**The Proposed Rookery South (Resource Recovery Facility)  
Order**

**Addendum to Flood Risk Assessment dated 4 August 2010**

9 May 2011

PROPOSED ROOKERY SOUTH RESOURCE RECOVERY FACILITY

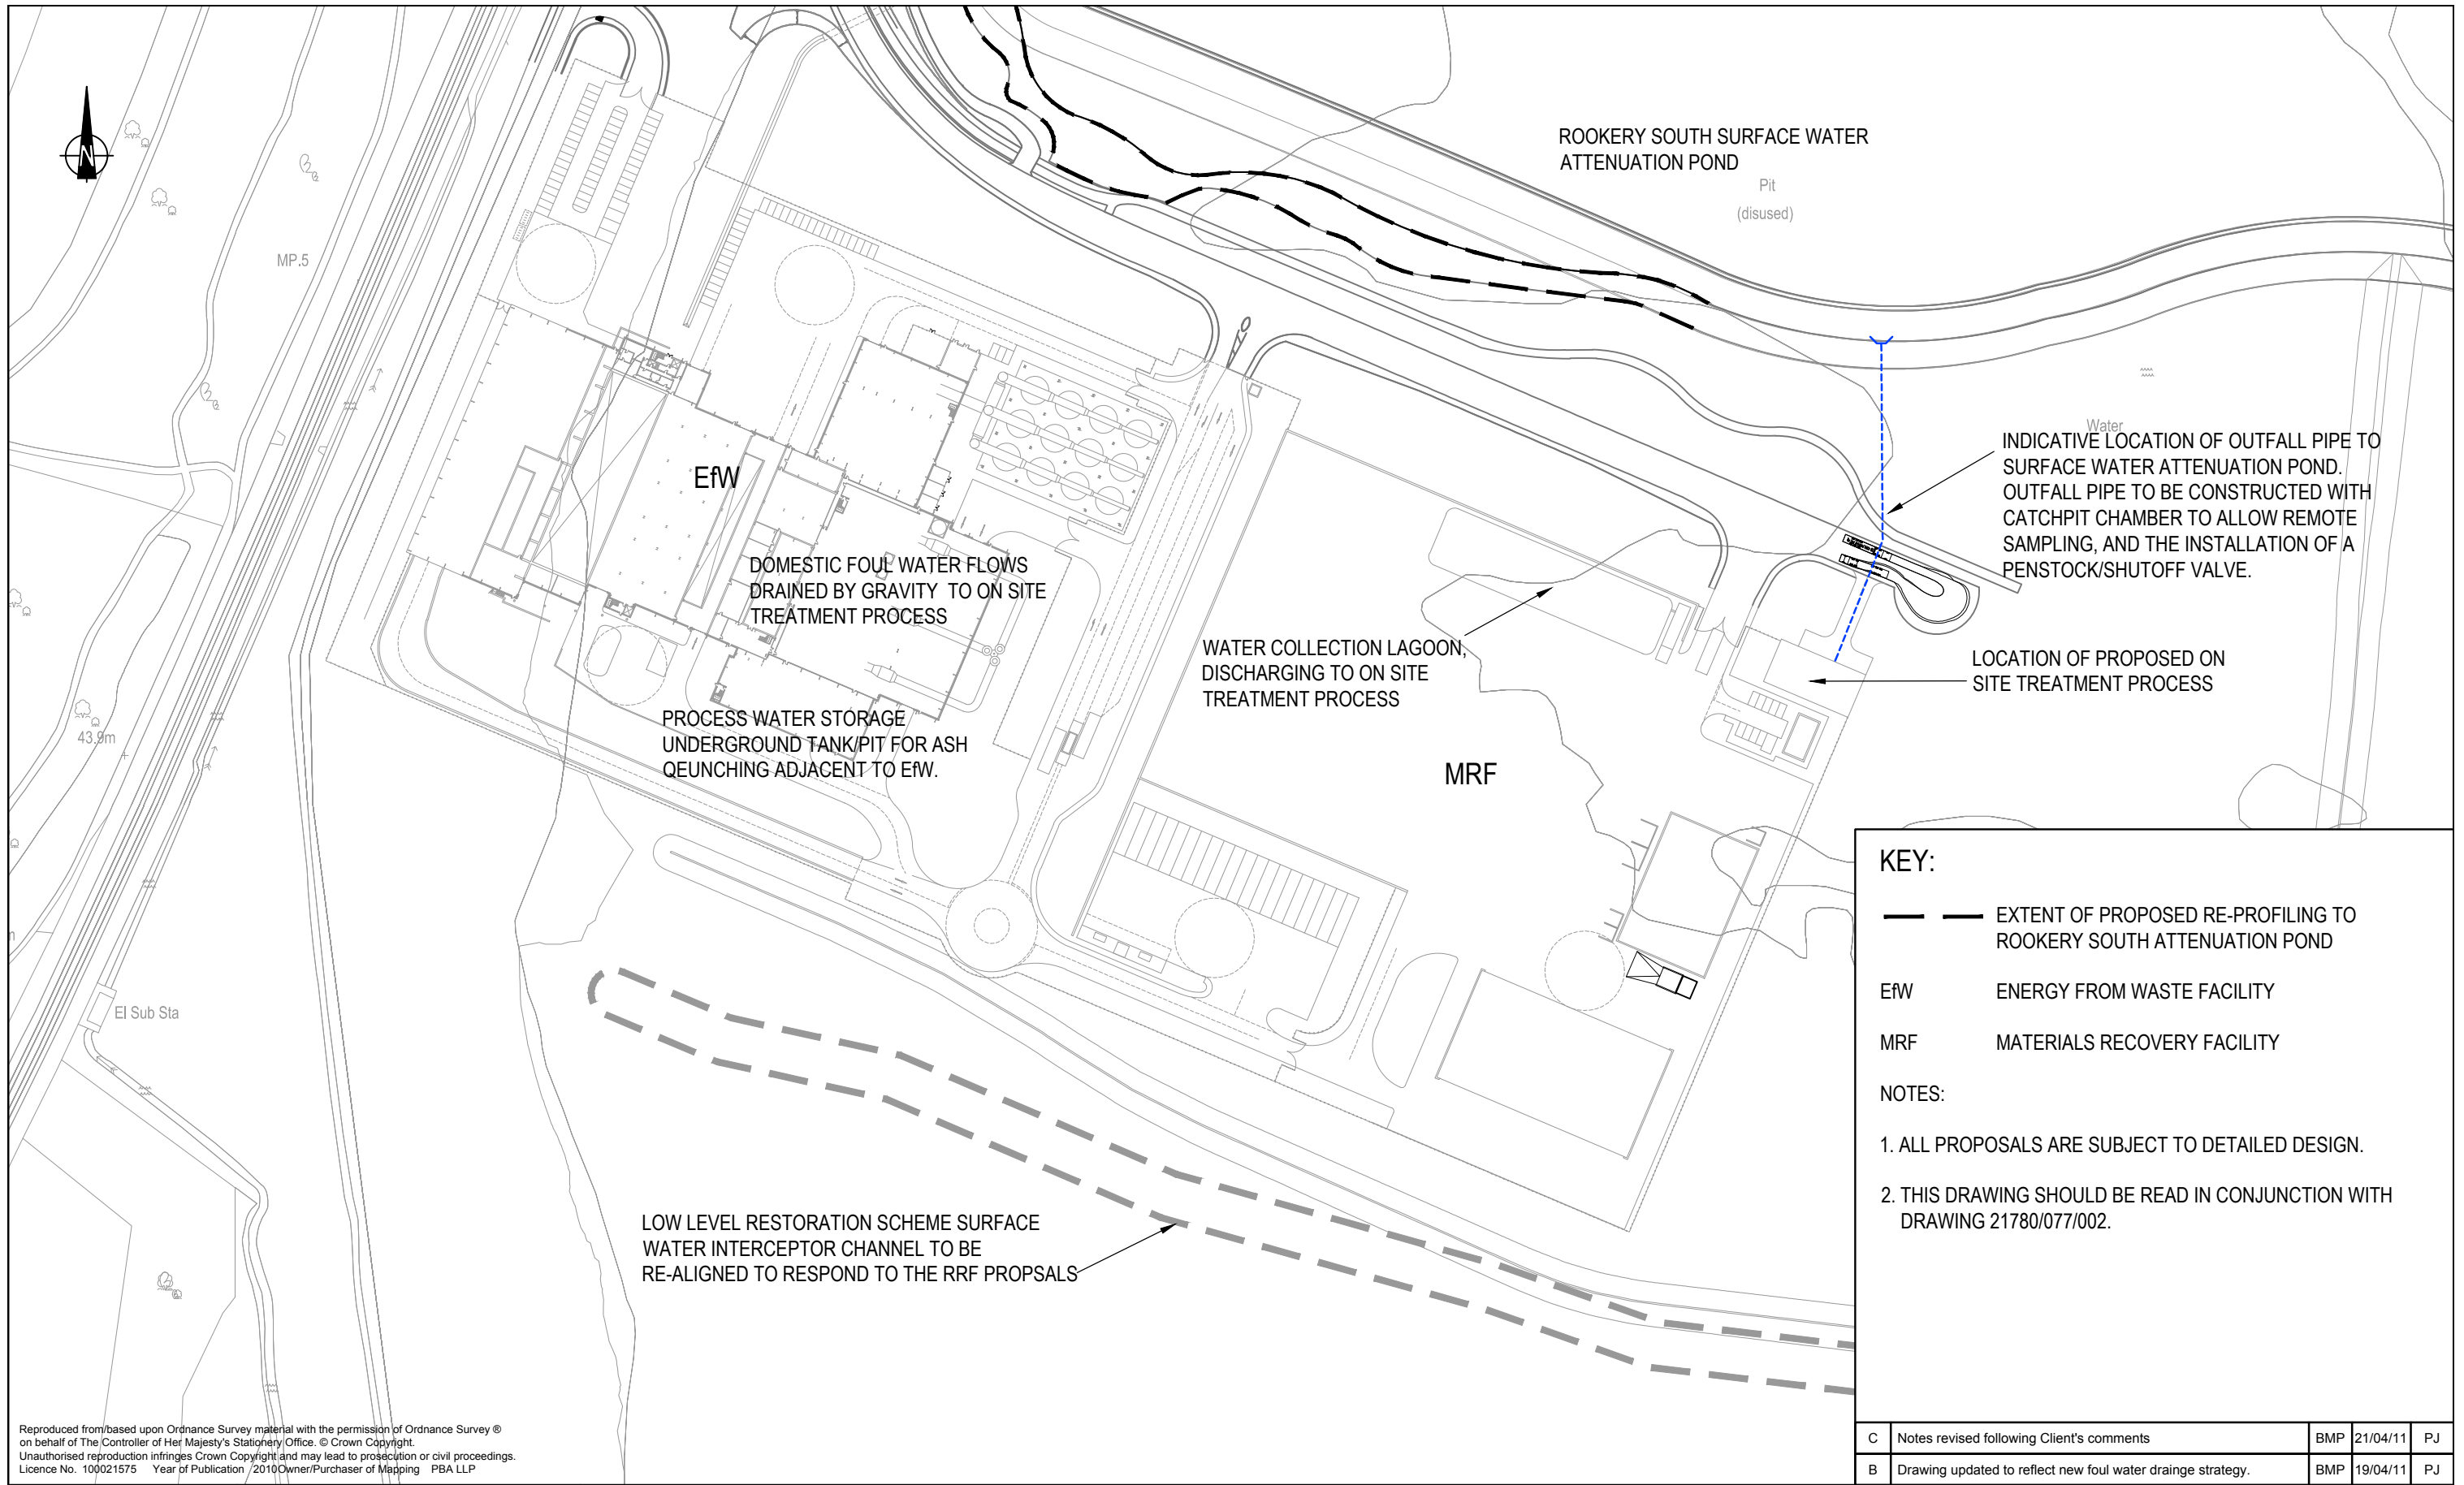
- 3.4. The RRF foul water drainage strategy will now therefore comprise the following:
- i) Domestic foul water flows (toilets, shower rooms, and kitchen facilities etc) will be drained via a private gravity foul water drainage network within the RRF outfalling to a Rotating Biological Contactor (a well established 'package' aerobic biological plant used for treating domestic waste water) for treatment. The domestic foul water flows remain estimated to be approximately 14m<sup>3</sup>/day, which equates to 0.16l/s.

- iv) Effluent from the two processes set out above will be returned to the EfW for use in the EfW process.
  - v) Any surplus treated effluent at any one time in excess of the EfW process requirements or available storage will be discharged to the Low Level Restoration Scheme surface water attenuation pond located to the north of the RRF, and then pumped as part of the wider LLRS surface water drainage strategy. The rate of any such surplus discharge to the surface water attenuation pond would be at a maximum rate of approximately 5l/s.

C	Notes revised following Client's comments	BMP	21/04/11	PJ
B	Drawing updated to reflect new foul water drainage strategy.	BMP	19/04/11	PJ
A	Drawing updated to respond to latest masterplan.	EJC	24/08/10	PJ
Mark	Revision	Drawn	Date	Chkd

### PROPOSED ROOKERY SOUTH RESOURCE RECOVERY FACILITY SCHEMATIC OF THE WATER COLLECTION LAGOON AND FOUL WATER DRAINAGE STRATEGY

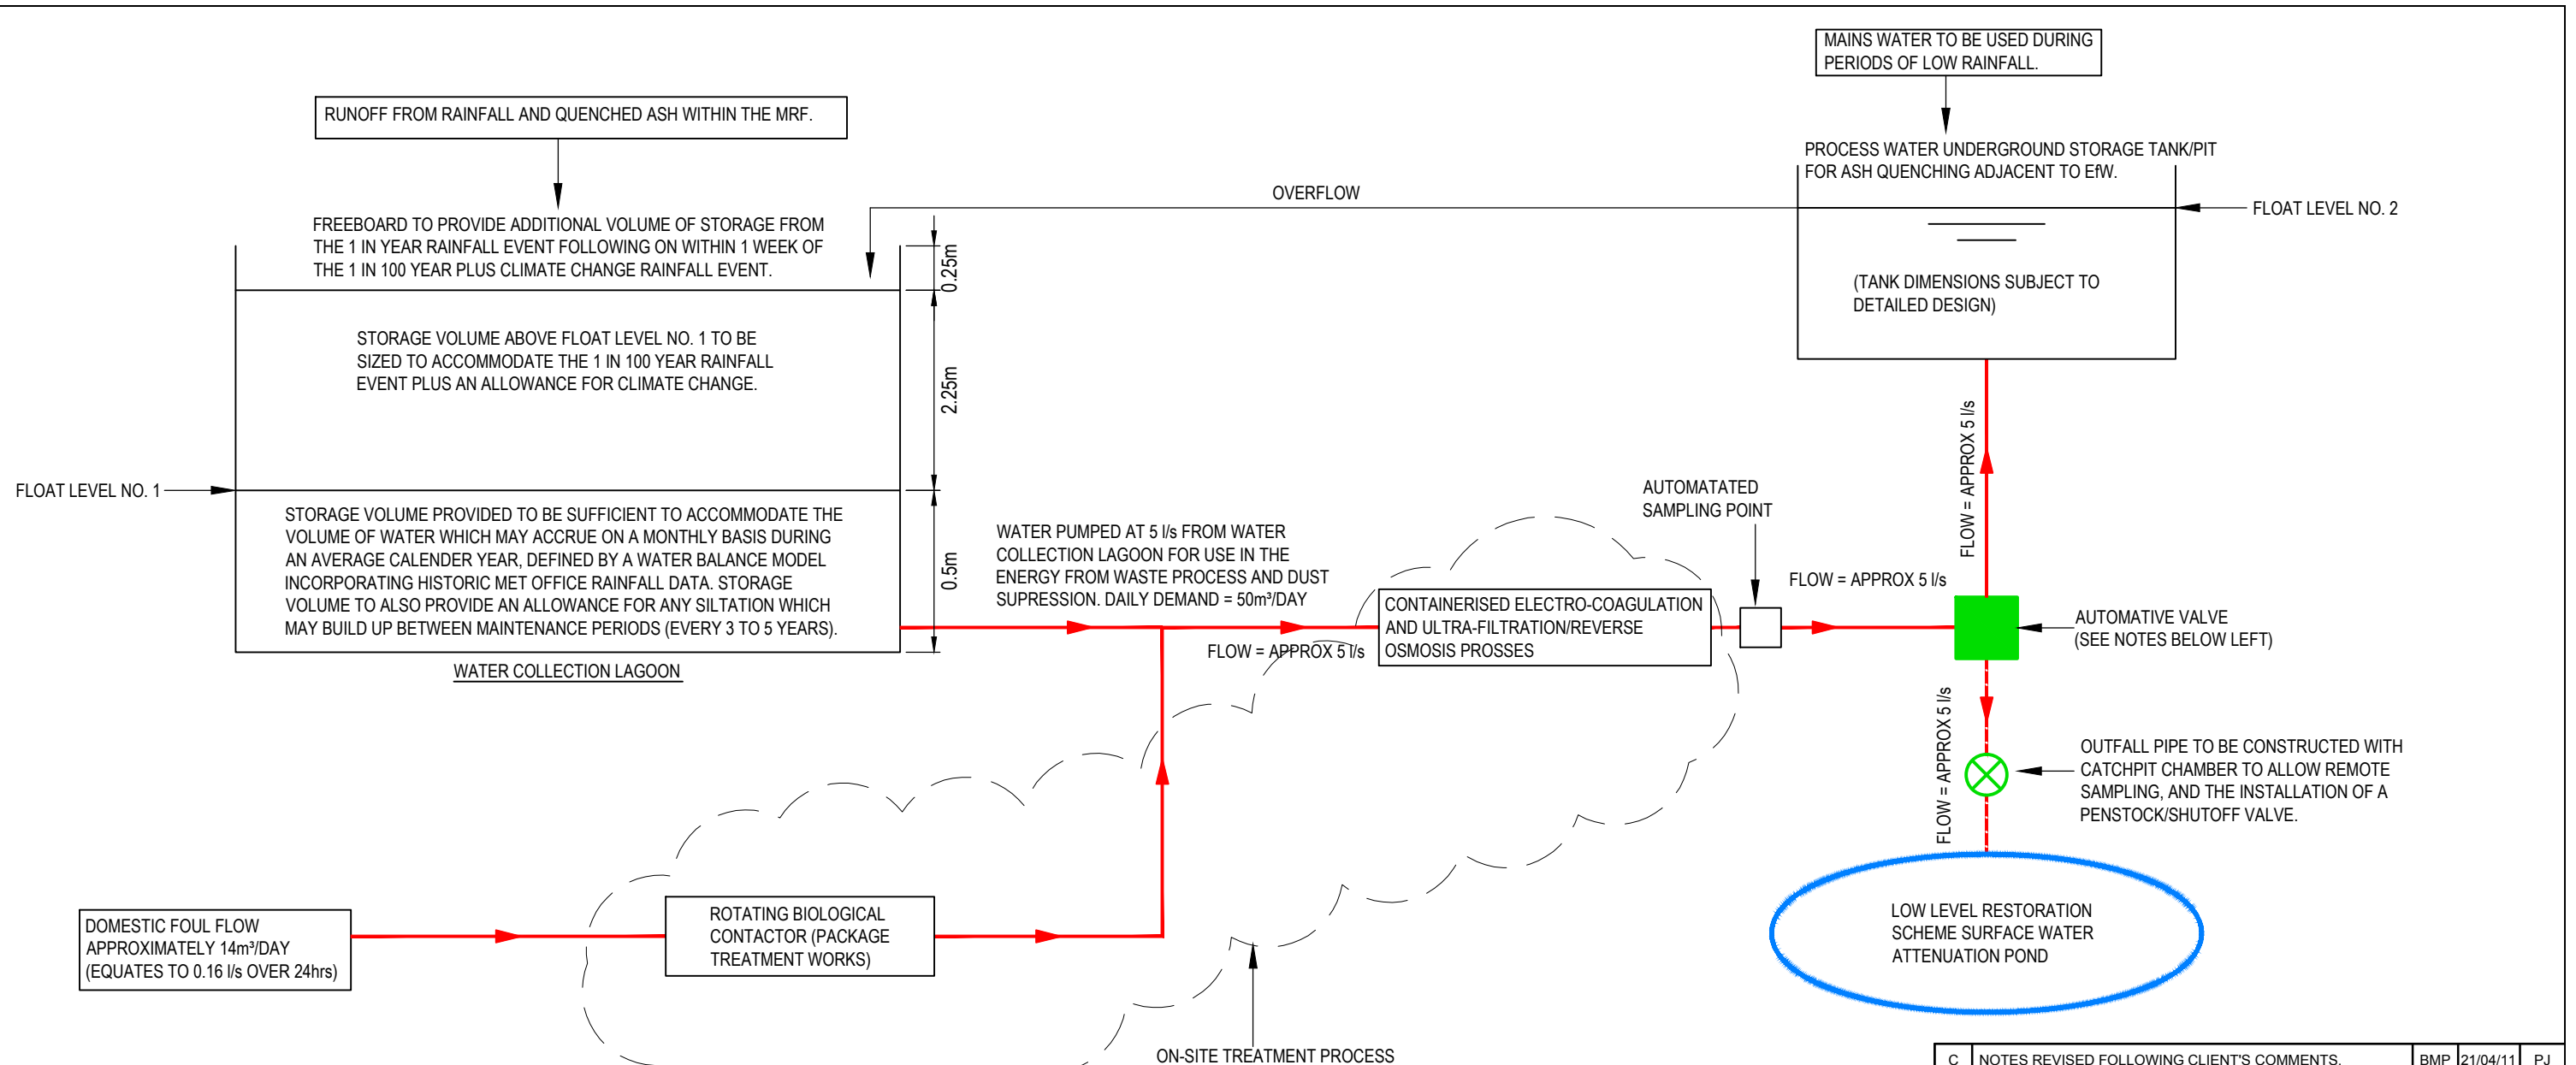
- ii) Runoff from the MRF water collection lagoon will be drawn down at a maximum rate of 5l/s and treated via a containerised electro-coagulation process with pH correction for general removal of contaminants, sulphates, solids, ammonium etc. The runoff will then be passed through a containerised ultra-filtration / Reverse Osmosis (RO) process for reduction of chlorides.

- iii) The treated effluent from the Rotating Biological Contactor (set out above) will be routed through the containerised electro-coagulation and ultra-filtration / Reverse Osmosis process to further improve the effluent quality.

C	NOTES REVISED FOLLOWING CLIENT'S COMMENTS.	BMP	21/04/11	PJ
B	ADDED NEW FOUL DRAINAGE STRATEGY TO DRAWING	TA	12/04/11	PJ
A	ADDITIONAL NOTATION ADDED TO DRAWING	EJC	24/06/10	CST
Mark	Revision	Drawn	Date	Chkd

D	NOTE REVISED TO CONFIRM TREATMENT TECHNOLOGY	BMP	05.05.11	PJ
---	--	-----	----------	----

1. AUTOMATIVE VALVE SET TO ALLOW FLOWS TO BE PUMPED TO EW WATER STORAGE TANK UNTIL FULL (AS DETERMINED BY FLOAT LEVEL NO.2)
2. IF THE EW WATER STORAGE TANK IS FULL AND THE WATER LEVEL IN THE WATER COLLECTION LAGOON IS ABOVE FLOAT LEVEL NO. 1, THE AUTOMATIVE VALVE WILL SWITCH TO ALLOW DISCHARGE OF FLOWS TO THE LOW LEVEL RESTORATION SCHEME SURFACE WATER ATTENUATION POND.
3. IF THE EW WATER STORAGE TANK IS FULL AND THE WATER LEVEL IN THE WATER COLLECTION LAGOON IS BELOW FLOAT LEVEL NO. 1, PUMPING FROM THE WATER COLLECTION LAGOON WILL CEASE BUT DOMESTIC FOUL FLOWS WILL CONTINUE TO BE TREATED AND DISCHARGED TO THE LOW LEVEL RESTORATION SCHEME SURFACE WATER ATTENUATION POND.

FIGURE 1 PROPOSED TREATMENT PROCESS LAYOUT

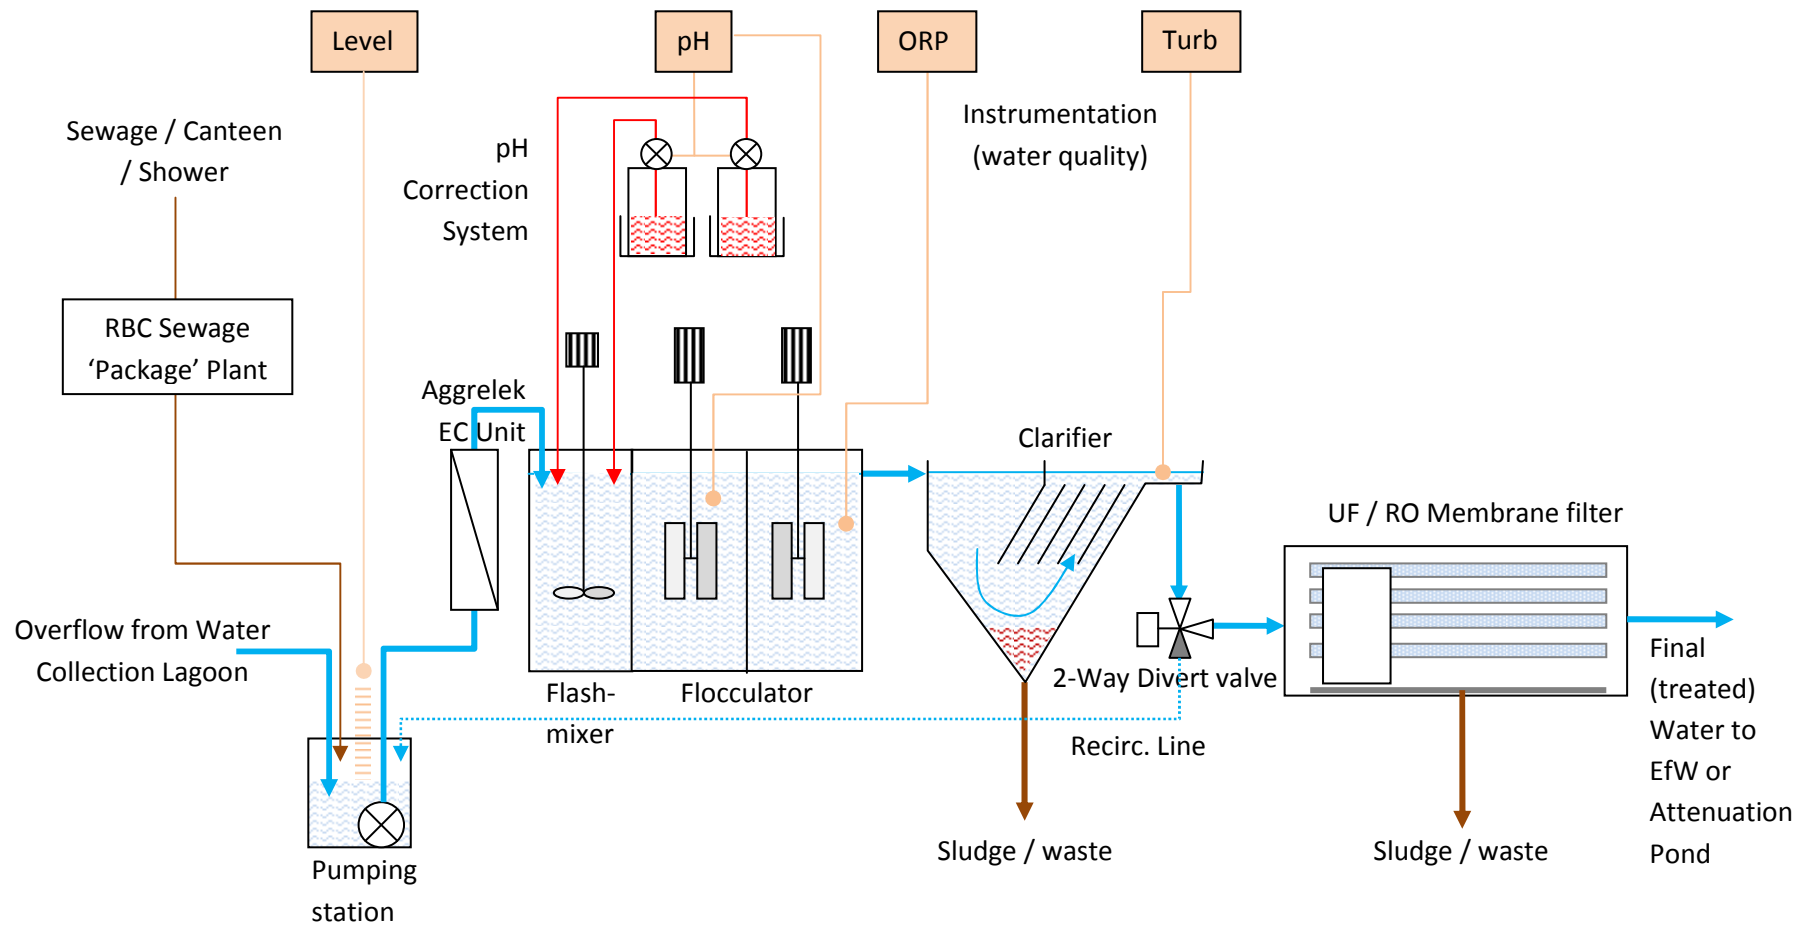
Treated sewage and excess water from the Water Collecting Lagoon will discharge directly to a Pumping Station which will feed a front-end Aggrelek electro-coagulation and pH correction followed by Ultra filtration and RO treatment (Figure 1) prior to discharge to Rookery South Surface Water Attenuation Pond.
